# Access Compliance Report

## Public Rights-of-Way

### (Curb Ramps)

Intersection ID: 44317	Main Street: E_9TH_ST	Cross Street: N_CALDWELL_ST	Location: E
ADA ID: 04D65C117262	Ramp Type: Perp	Initial Pass/Fail: Fail	Overall Compliance: No
Severity Score: 8.75			
Codes/Mitigation Info/Possible Solution		Field Measurements/Component Compliance

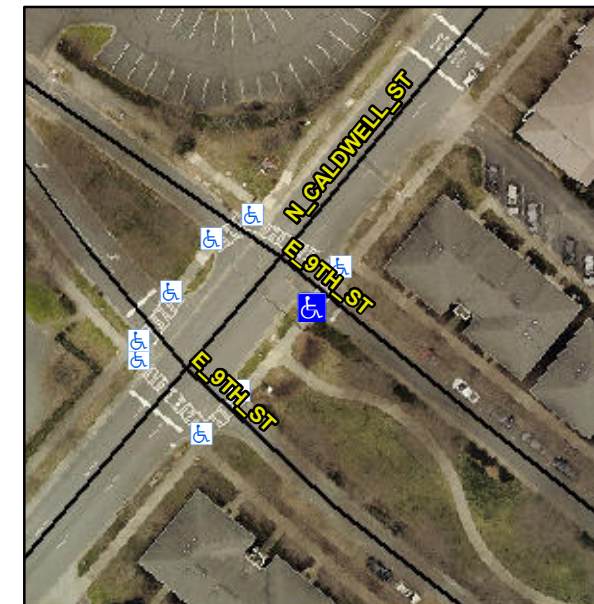
**Not Found, R304.5.1**

Compliance	Description	Data	Compliance	Description	Data
N/A	Ramp Length (in)	72.0	Yes	Ramp Slope (%)	6.5
No	Ramp Width (in)	47.0	Yes	Ramp XSlope (%)	1.8
N/A	Flare Type LT	N/A	N/A	Flare Type RT	N/A
N/A	Flare Slope LT (%)	N/A	N/A	Flare Slope RT (%)	N/A
N/A	Flare Traversable LT?	N/A	N/A	Flare Traversable RT?	N/A
N/A	Landing Length (in)	N/A	N/A	DWS Provided?	N/A
N/A	Landing Width (in)	N/A	N/A	DWS Contrast?	N/A
N/A	Landing Slope (%)	N/A	N/A	DWS Length (in)	N/A
N/A	Landing X Slope (%)	N/A	N/A	DWS Full Width?	N/A
N/A	Landing Curb? (Y/N)	N/A	N/A	DWS Offset (in)	N/A
N/A	Shared Landing?	N/A			
N/A	Gutter Ponding?	N/A	N/A	Gutter Slope (%)	N/A
N/A	Gutter Lip Ht (in)	N/A	N/A	Gutter X Slope (%)	N/A
N/A	Painted X Walk1?	Yes	N/A	Painted X Walk2?	N/A
	X Walk 1 Direction	To NE		X Walk 2 Direction	N/A
N/A	X Walk 1 Width (in)	108.5	N/A	X Walk 2 Width (in)	N/A
	X Walk 1 Slope (%)	0.4		X Walk 2 Slope (%)	N/A
	X Walk 1 X Slope (%)	3.2		X Walk 2 X Slope (%)	N/A

**Remove & Replace Entire Ramp.**
